Technical Note

Project No: ITB11347
Project Title: Mill Lane, Hatfield Heath
Title: Response to ECC Consultation: UTT/22/1261/FUL
Ref: ITB11347-008A TN
Date: 4 November 2022

SCALE @ AS:	CHECKED:	APPROVED:
AS SHOWN	SJ	SJ
FILE REF: ITB11347	DRAWN: SH	DATE: 14.09.16
DRAWING No: ITB11347-GA-006		
PROJECT No: ITB11347		REV: D

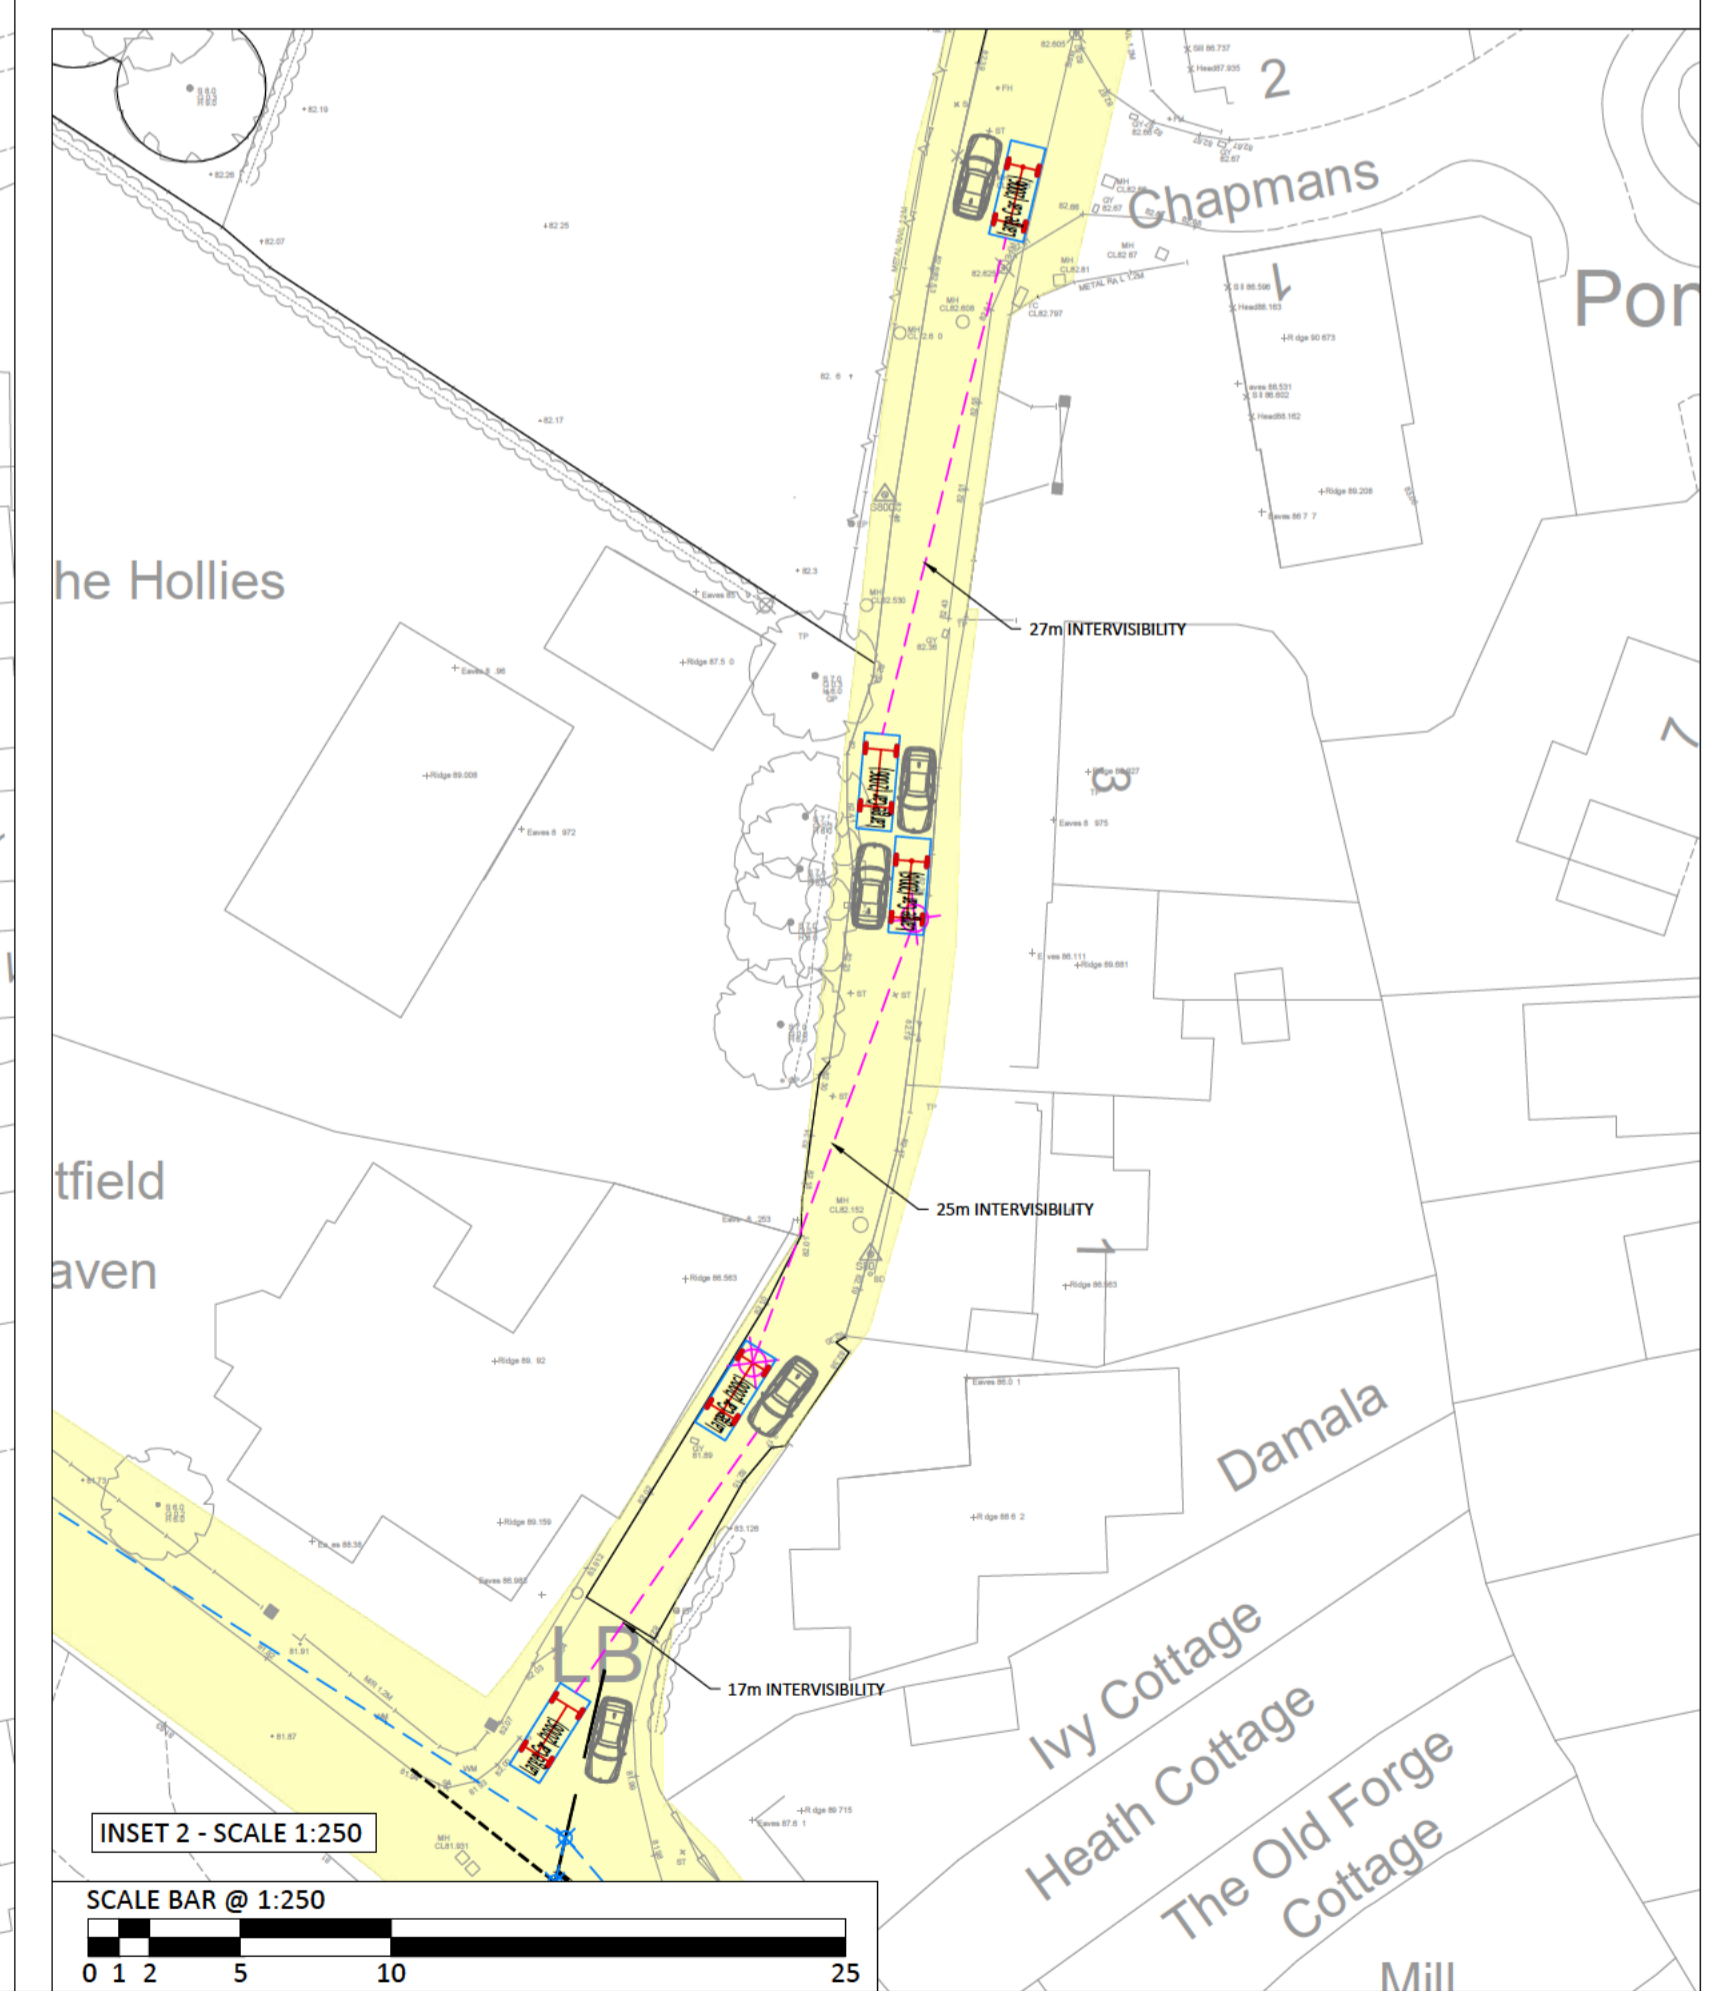
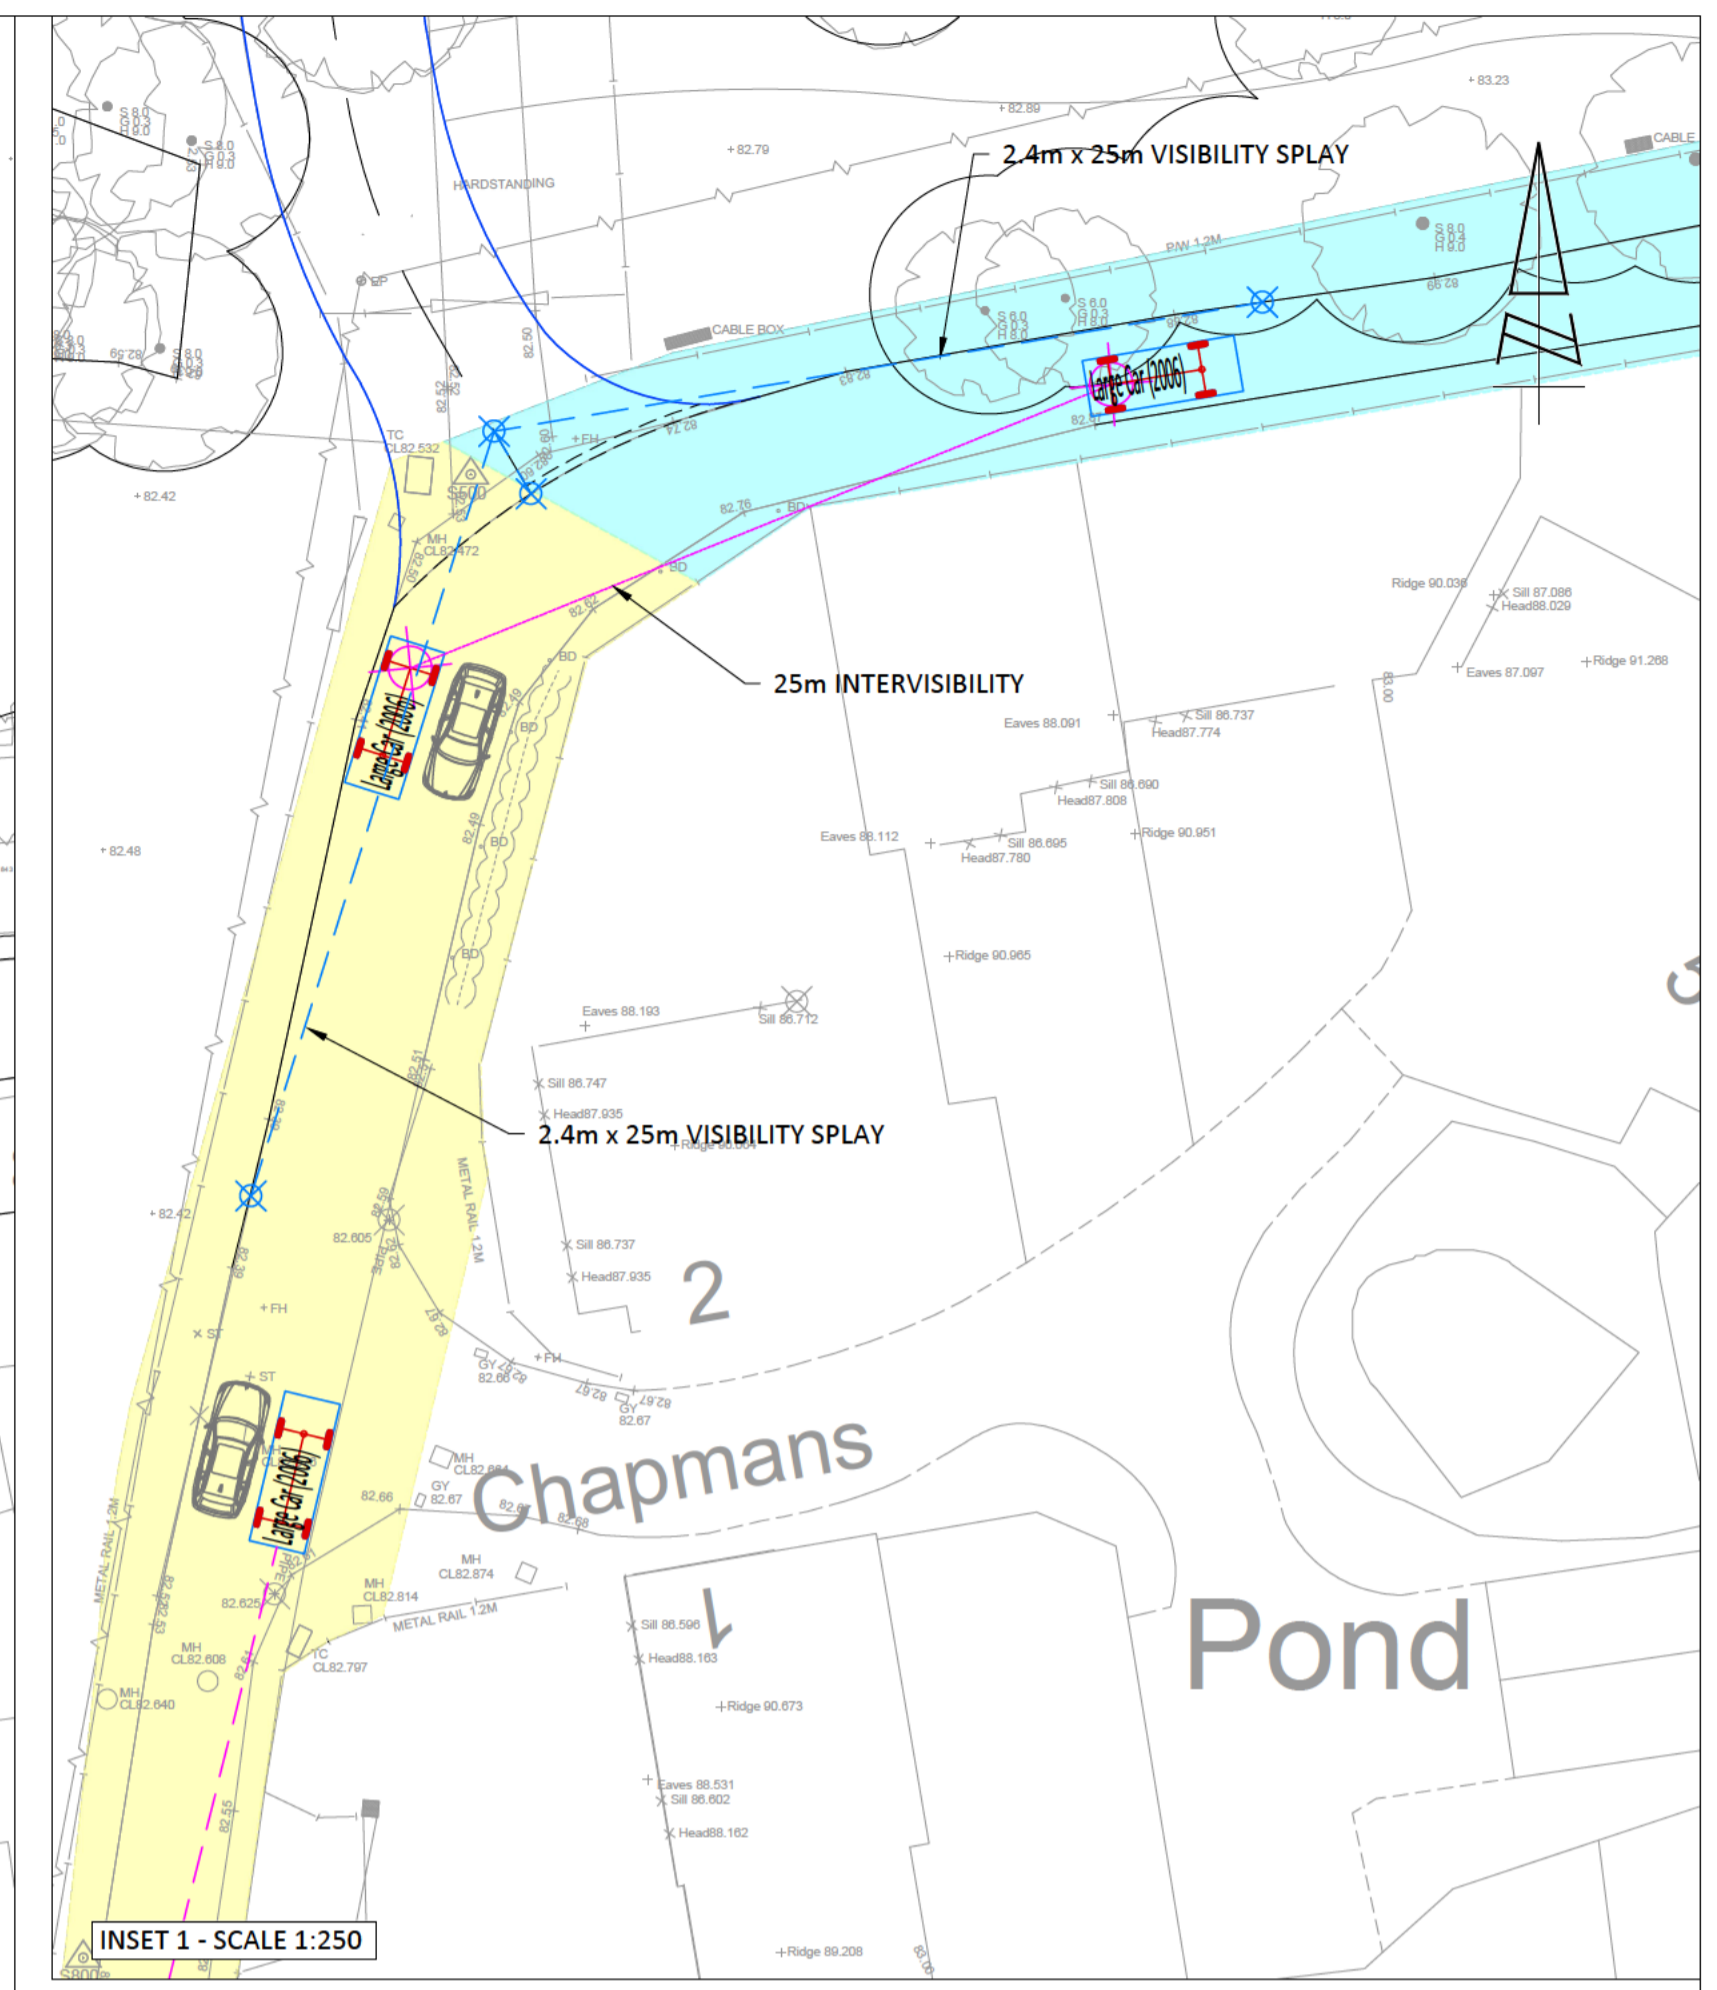
2.3.1 ECC have outlined that Mill Lane has deficiencies in geometric layout and visibility and at points falls below 4m in width, not allowing two cars to pass.

- 3.1 ECC have identified four points under this section, set out as follows:
- a* Visibility splays from the junction of Mill Lane with Stortford Road should be provided.
 - b* Visibility splays from the access to the terraced housing should be provided in accordance with the guidance in *Manual for Streets*.

2.3.2 There are instances where Mill Lane does fall below 4m, but for the majority of the length of Mill Lane the width is 4.1m or greater as demonstrated in drawing ITB11347-GA-006 Rev D provided in the drawings section at the end of this note. Manual for Streets (MfS) demonstrates that roads which are of 4.1m in width allow two cars to pass. Therefore, for the majority of Mill Lane between Stortford Road and the proposed site access, cars can pass each other.

2.3.4 In relation to sections 1 and 3, these are very limited sections of the lane and are located on "straights" and immediately either side are sections of wider carriageway, which allow two cars to pass. As these very short sections are located on "straights," generous intervisibility between vehicles approaching them is achieved and is shown in Inset 2 on Drawing ITB11347-GA-006 Rev D.

3.2 In regard to point (a), this was shown in Drawing ITB11347-GA-006 Rev B in the Transport Statement. Drawing ITB11347-GA-006 Rev D provided in the drawing section at the end of this note, makes the visibility clearer, but as per the Transport Statement, the visibility shown achieves 120m to the north - which is the requirement for a 40mph speed limit, whilst the junction is located in a 30mph speed limit, which would require a 43m visibility requirement, which is the visibility shown to the south of the junction.
